STAFF REPORT
(One-Step Final Plat)

CASE NUMBER: S/D 99-80 -- RAINBOW ESTATES 2ND ADDITION

VICINITY MAP

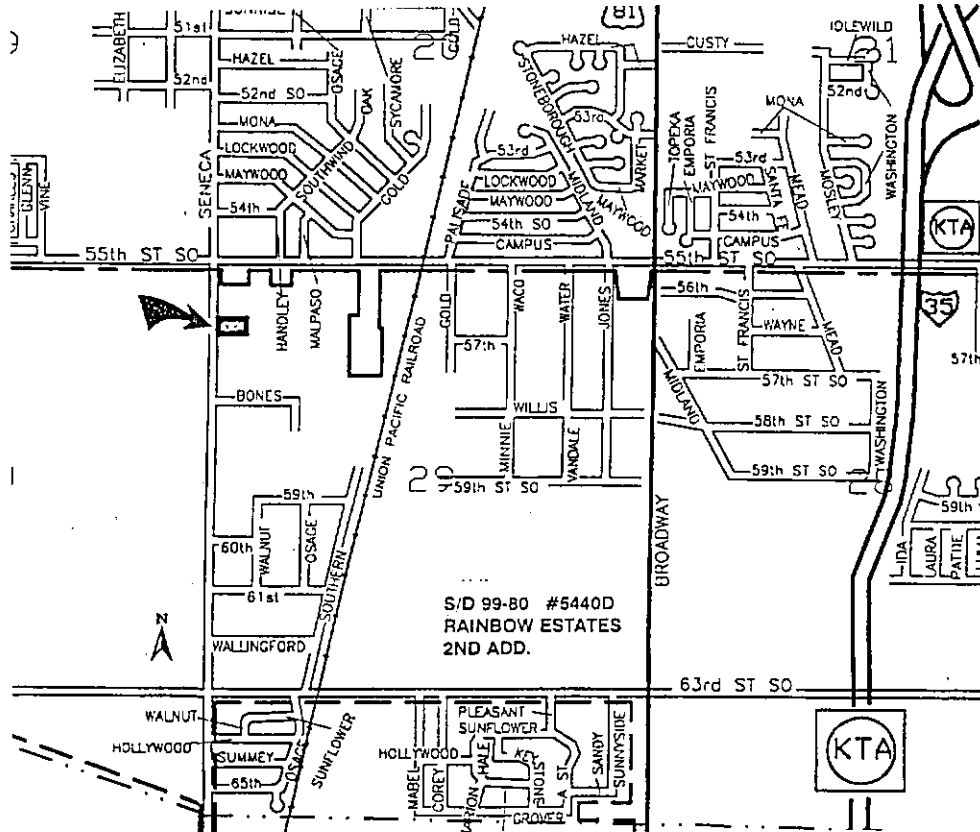
*SS ext
w. is petitioned
and being designed*
